SUBJECT: GENERIC FUNDAMENTALS EXAMINATION RESULTS

## FACILITY COMMENTS AND NRC RESPONSES FOR THE OCTOBER 1996 GFE

FACILITY -- WATERFORD

EXAM -- PWR FORM A/B

QUESTION: 14/42

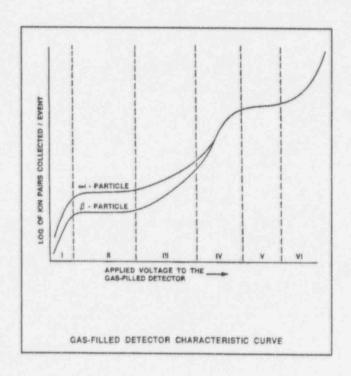
Question 14, in our opinion, is testing at a level equivalent to that which would be expected knowledge for a maintenance technician specializing in radiation instrumentation.

Do not concur. This question is supported by NRC generic component K/A 191002K118, "Theory and operation of ion chambers,..." According to Westinghouse (Radiation, Chemistry, and Corrosion Considerations for Nuclear Power Plant Application, 1983, p. 5-29), "In a high gamma field with high operating voltage, gamma pulse pile-up results in instrument output indicating a neutron flux much higher than actually exists." This makes option B the correct answer.

Based on the interim answer key, this question was answered correctly by 23/124 examinees and yielded a very small positive discrimination index of +0.02. No answer key change is required.
